Re: Rockville's Pike: Envision a Great Place
Rockville Pike Corridor Neighborhood Plan

Re: Rockville Pike Corridor Plan Update – 12303 Twinbrook Parkway (Lot 24, Block 7,
Halpine Subdivision)

Conceptual Design-Density Study

2.01b

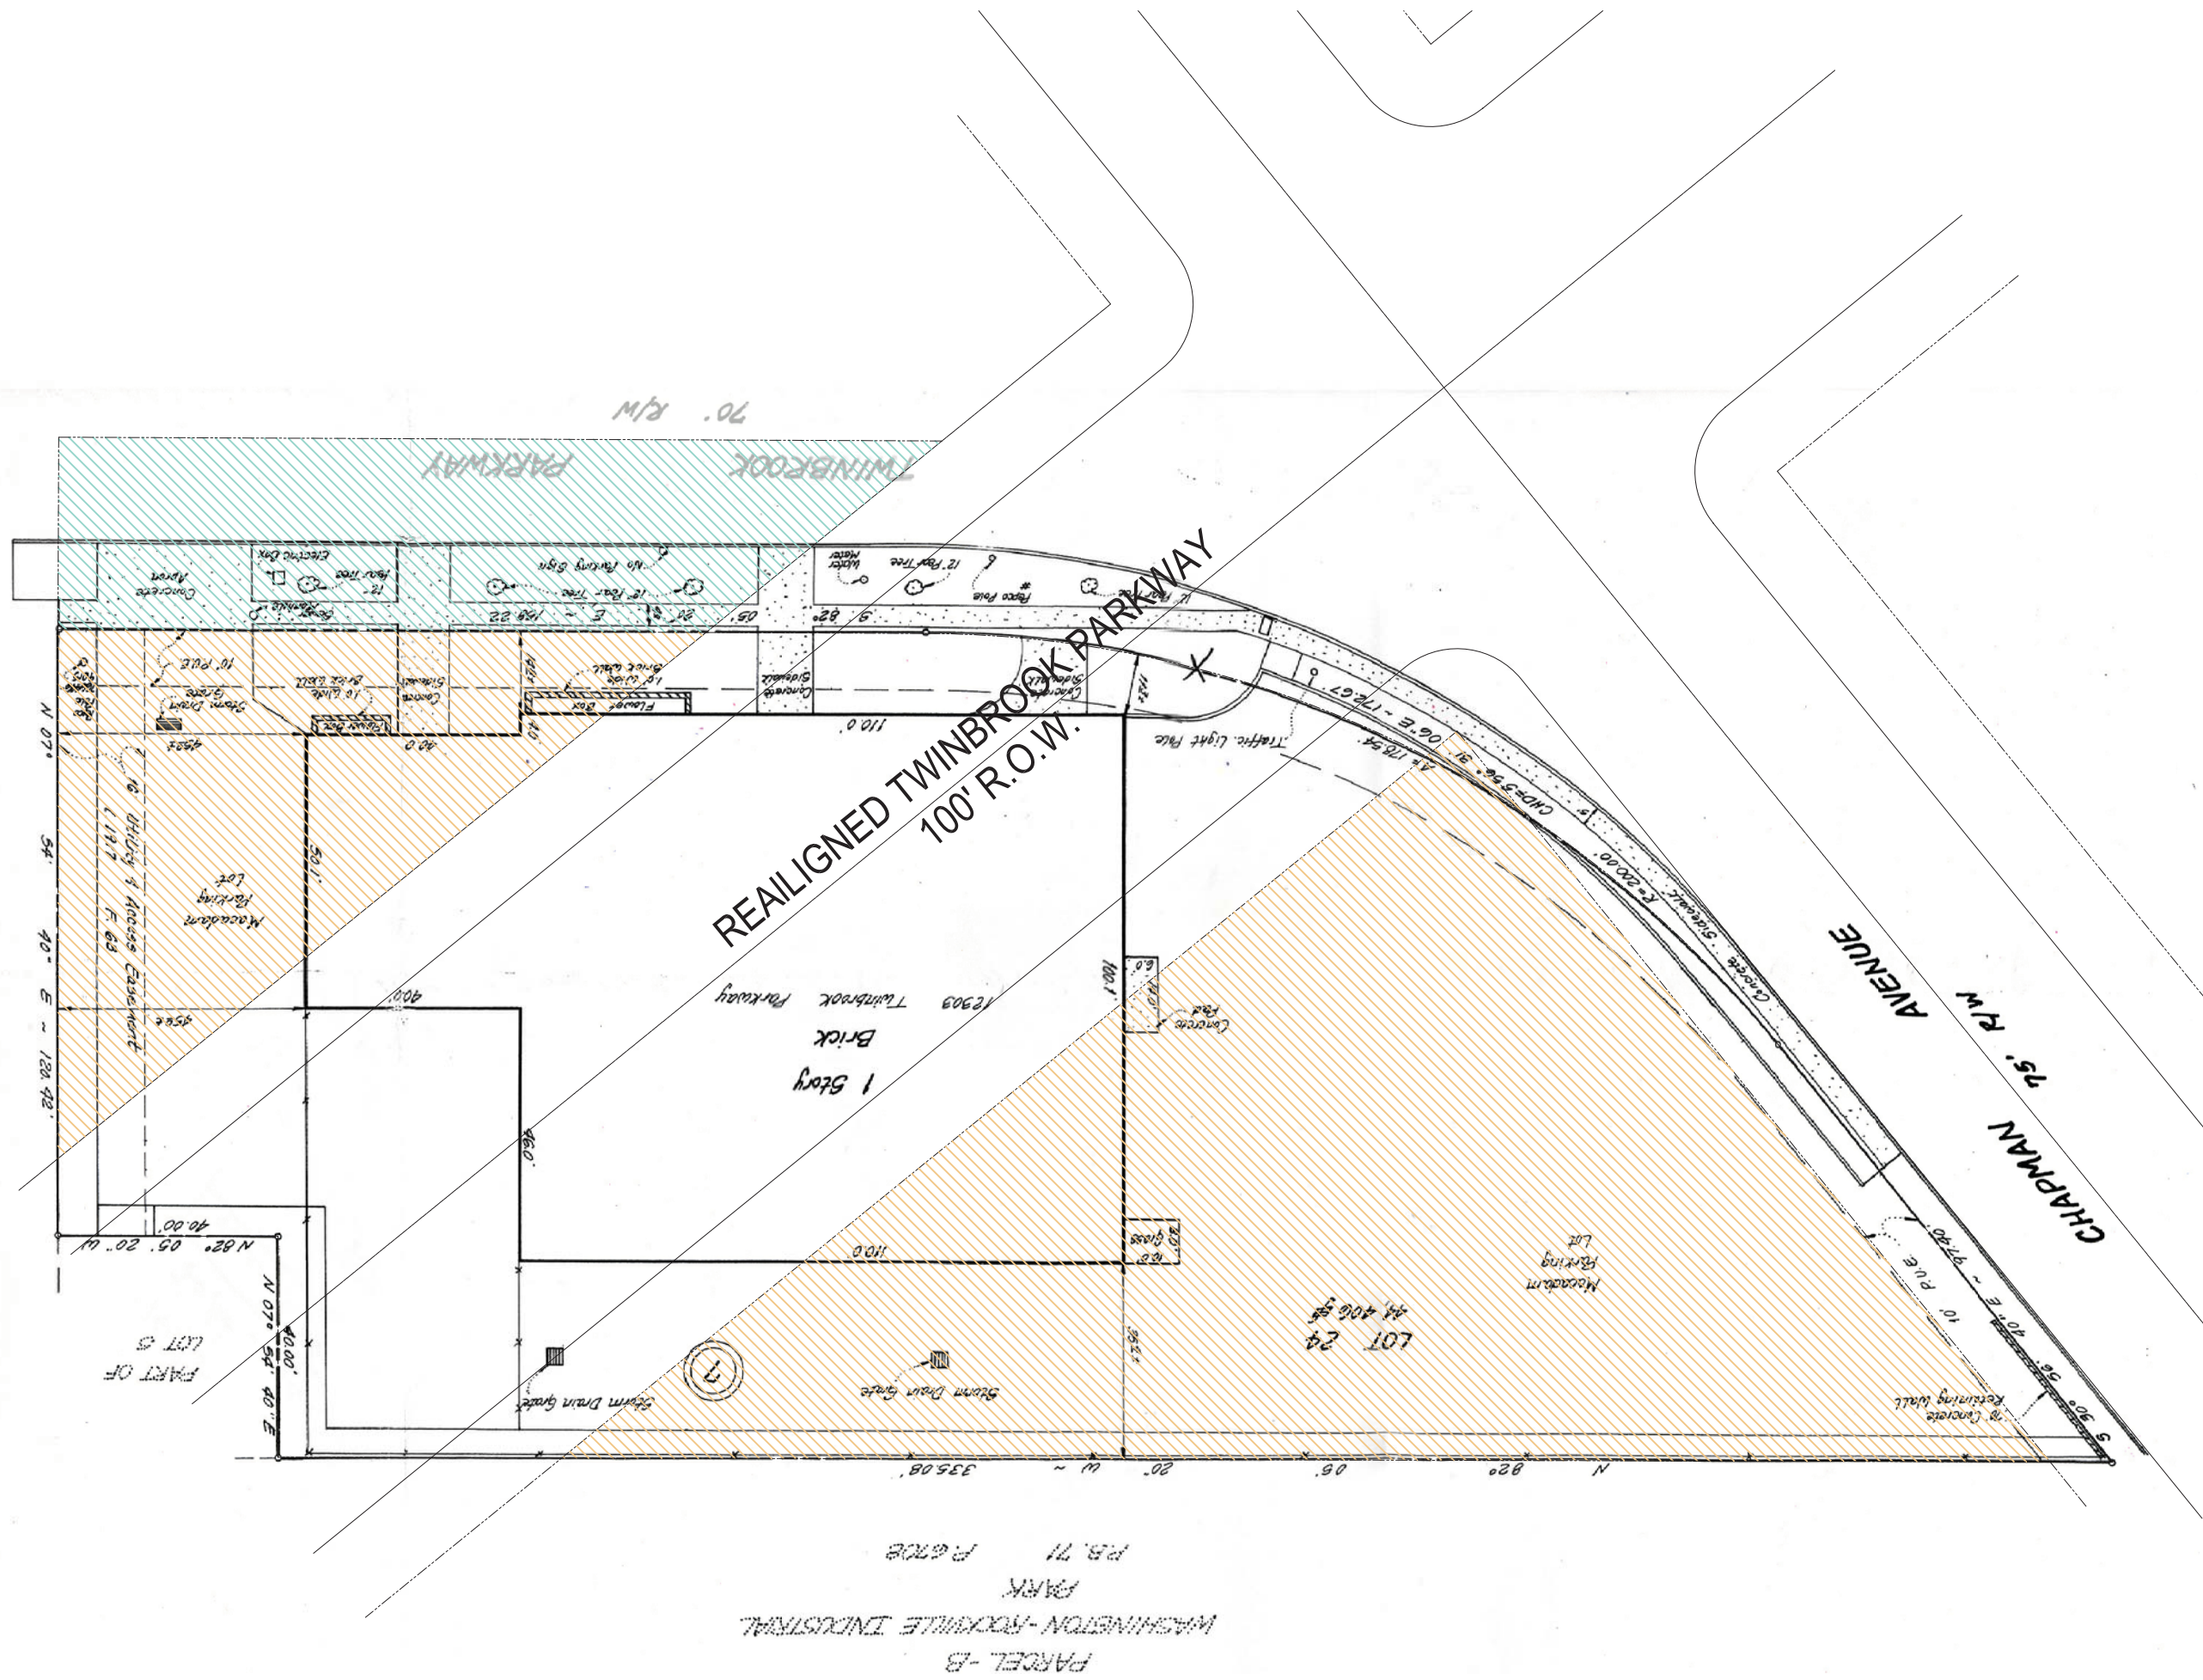
The Realty Group estimates the Property's redevelopment value under existing zoning to be in excess of \$12 Million. However, as shown on the enclosed materials, the realignment of Twinbrook Parkway would overwhelm the Property. Based on the realignment shown in the Draft Plan, the Property would be bisected by a 100' right-of-way. This would create two much smaller unusable parcels. Of course, if implemented, the realignment shown in the Draft Plan would also force the closure of the existing restaurant and demolition of the existing building and improvements.

realignment impact
City of Rockville's proposal
White Flint Express Realty Group Limited Partnership

2.02b

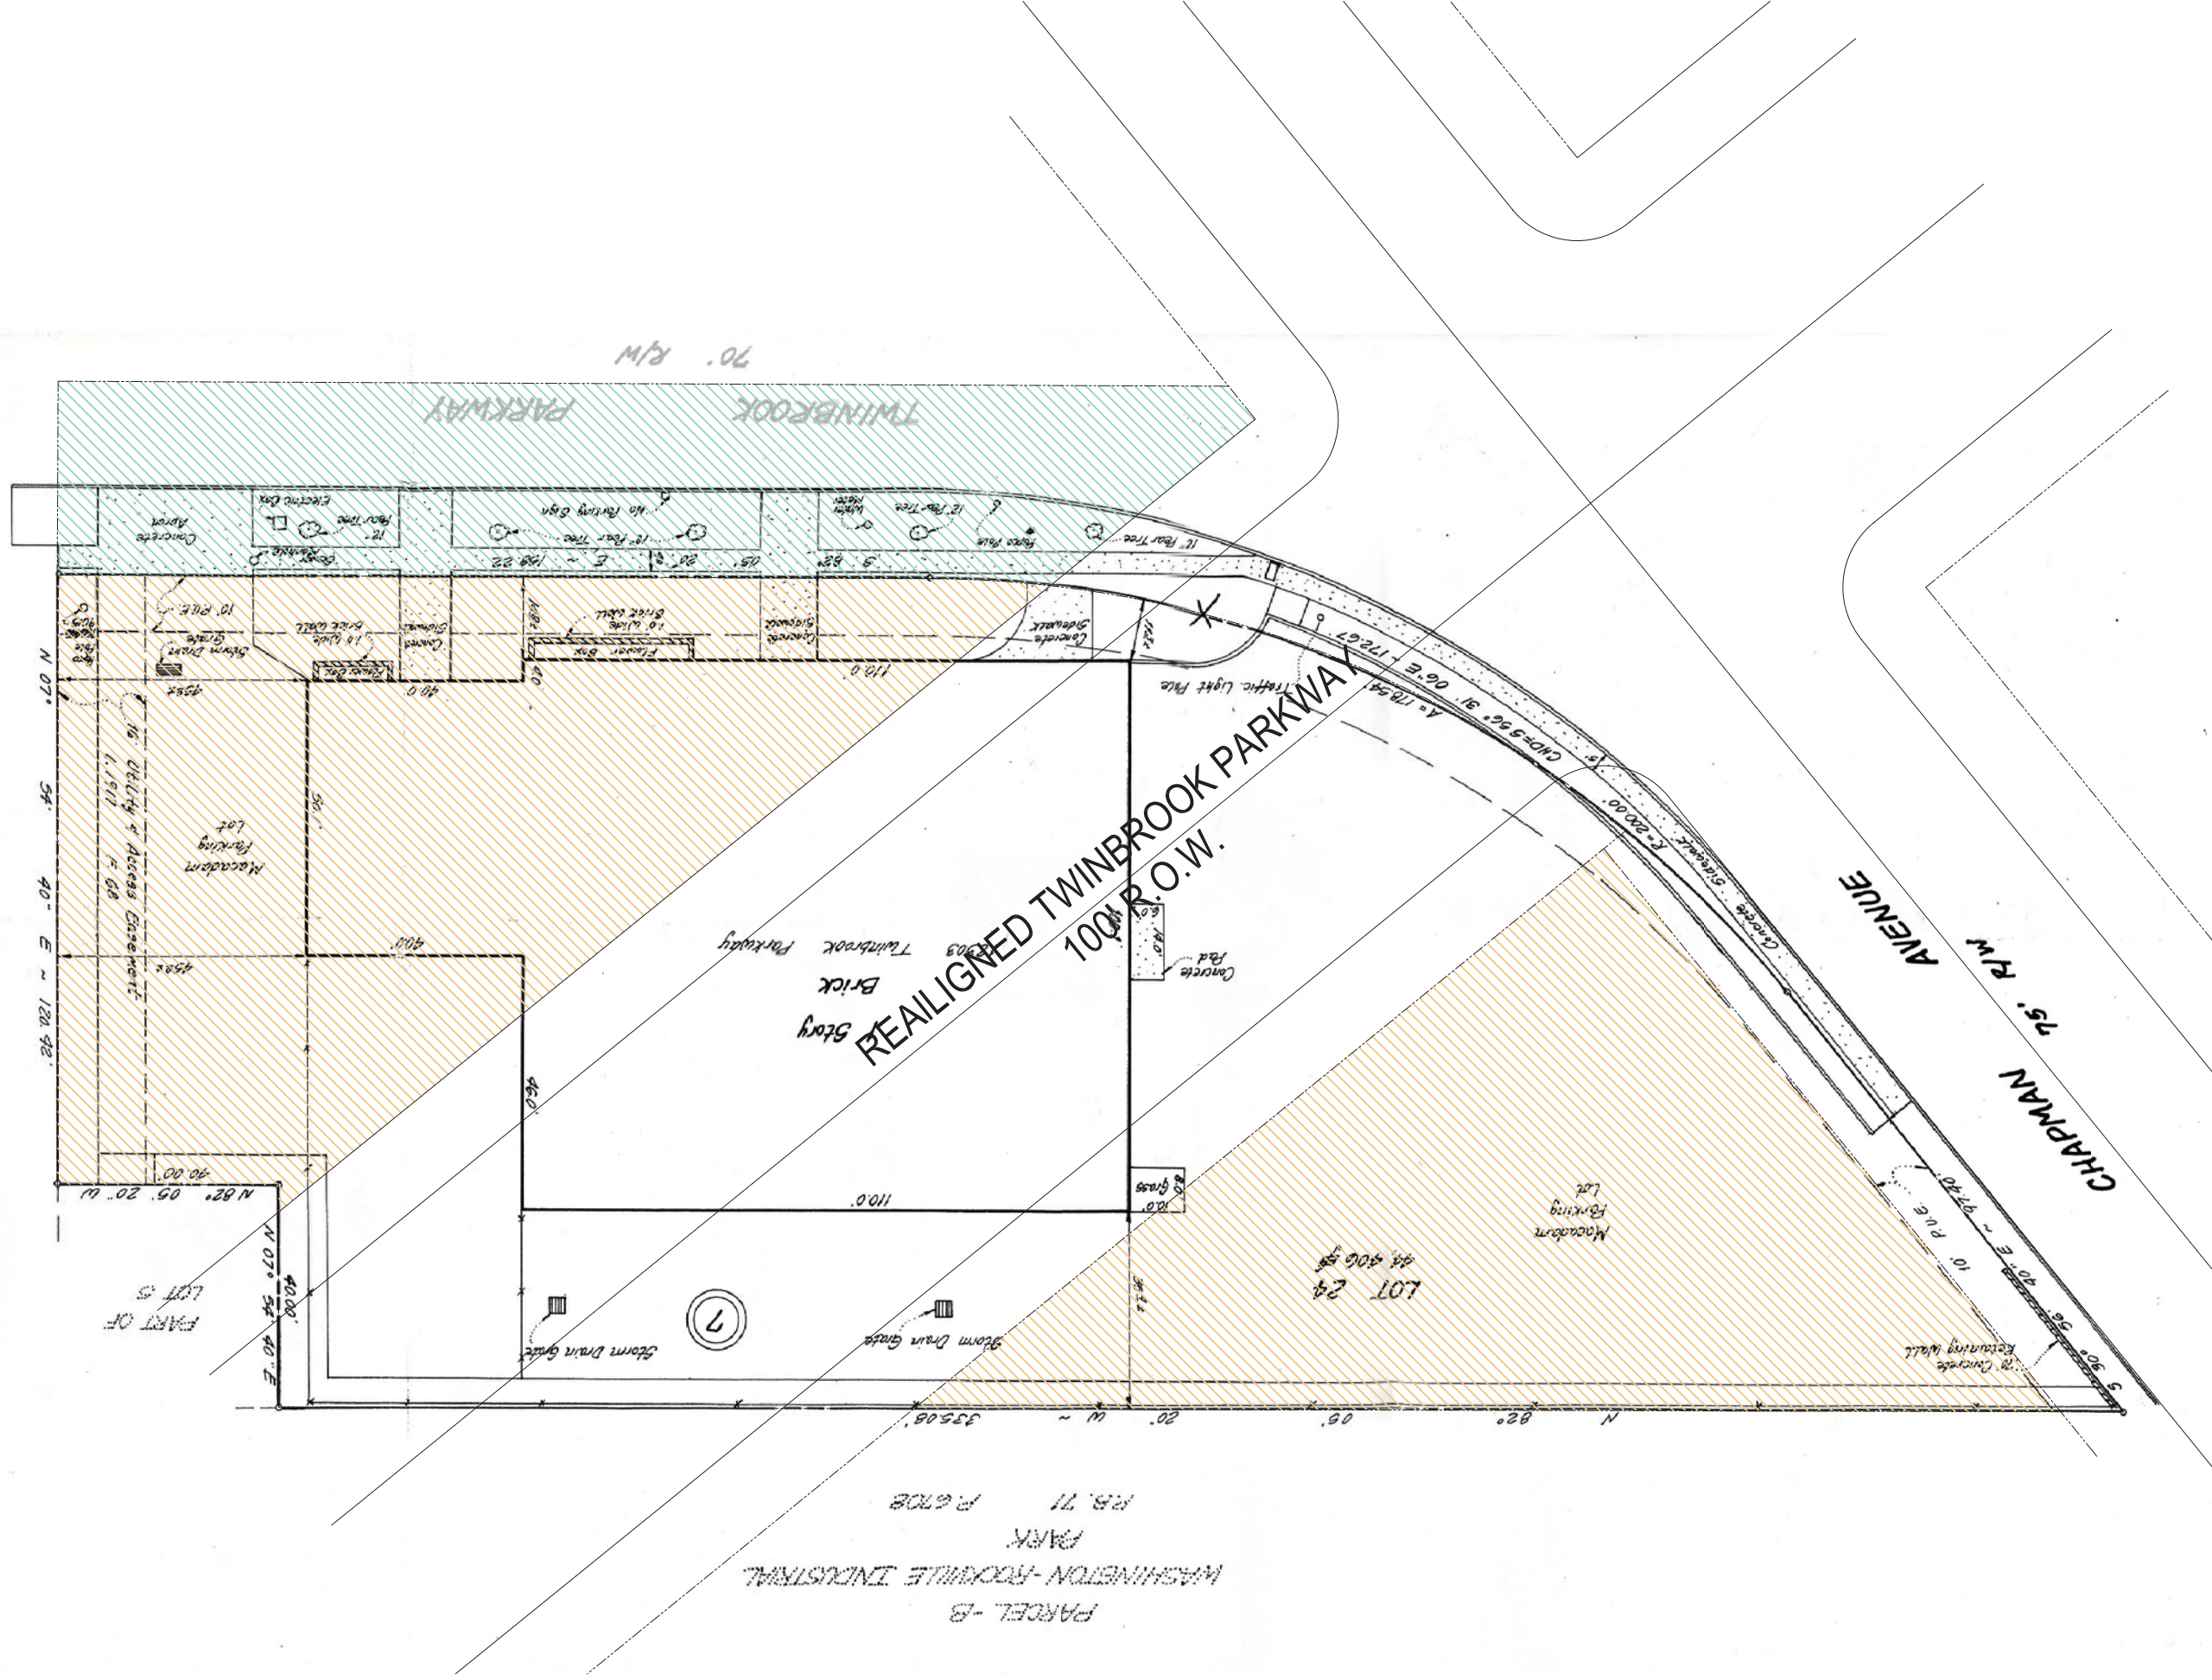
The Realty Group also asked SKI to evaluate whether an alternate realignment of Twinbrook Parkway might be feasible. As shown on the enclosed materials, SKI considered two options. Option 1 would realign Twinbrook Parkway to extend more logically from its curve near the railroad/Metro tracks to avoid the reverse curve depicted in the Draft Plan between Chapman Avenue and Rockville Pike (*see* Fig. 5.17). Unfortunately, this option would also severely impact the Property by bisecting it and again creating two much smaller unusable parcels.

realignment impact
proposal option 1
